Title: MTO2017 Oil Breather hose routing		
AG-SB-2023-01-C-EN	Effective Date: 01.04.2023	Compliance Category: A - MANDATORY B - RECOMMENDED C - OPTIONAL
Applicability		
Aircraft type & model: MTO2017	Affected Serial number(s): All MTO2017 produced before 07/2021	
The maintenance manual to be referenced is this stated or subsequent issue.		As per AutoGyro website
This form is the response from AutoGyro GmbH either against a problem found in the product in service requiring a containment or rectification action, or as service information for aircraft modification incorporation. For help, contact airworthiness@auto-gyro.com.

Illustrations

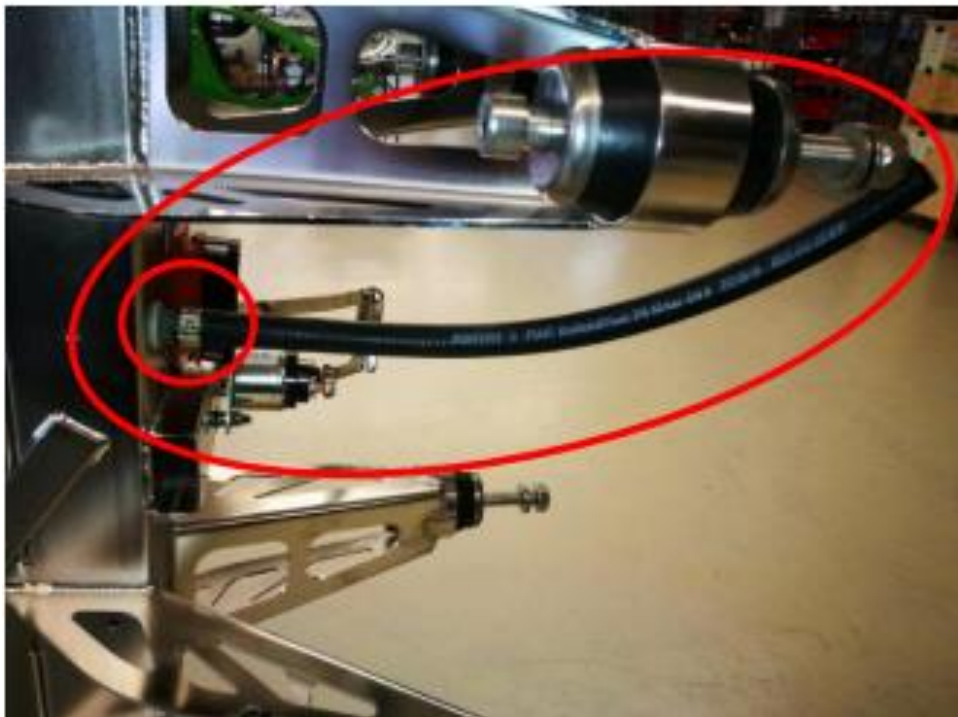
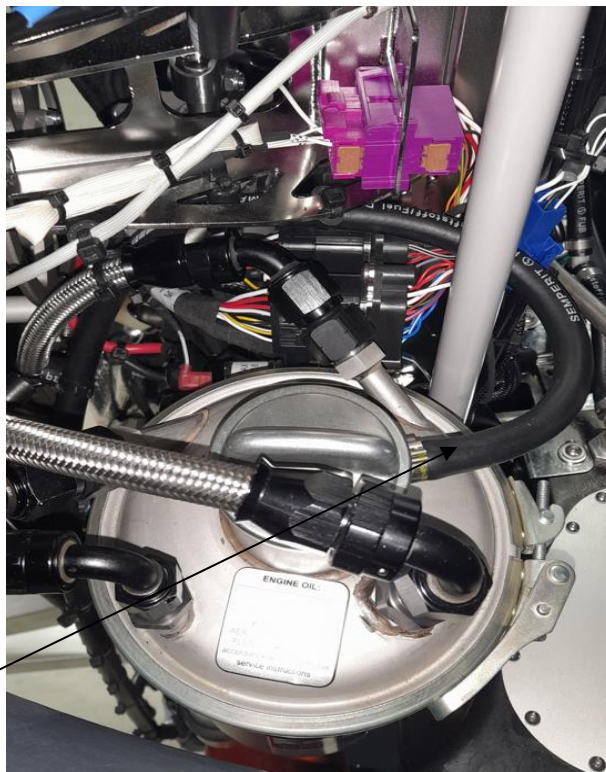
The oil breather hose is connected from the top of the oil tank into the stainless steel frame of the aircraft. The oil vapour of the engine should go overboard via the frame below the aircraft. Due to the fact that the frame has several openings in different places, it has been found in service that, in some circumstances, the oil vapour may be vented such that the occupants notice an oil smell.

This situation has been improved by extending the oil vent hose such that it leads directly to the lower end of the airframe cell where the oil vapour is blown away beneath the aircraft.

Old version of oil breather hose routing:

New routing of oil breather hose:

Remove the old oil breather hose from the tank and the mast. Install the new oil breather hose on the oil tank and fix it as shown on the pictures below.

Ensure that there is a cut in the hose near the tank in the same position as the removed hose. This cut is to allow the engine to oil system to breath in the event that the moisture in the lower part of the breather tube freezes in flight.
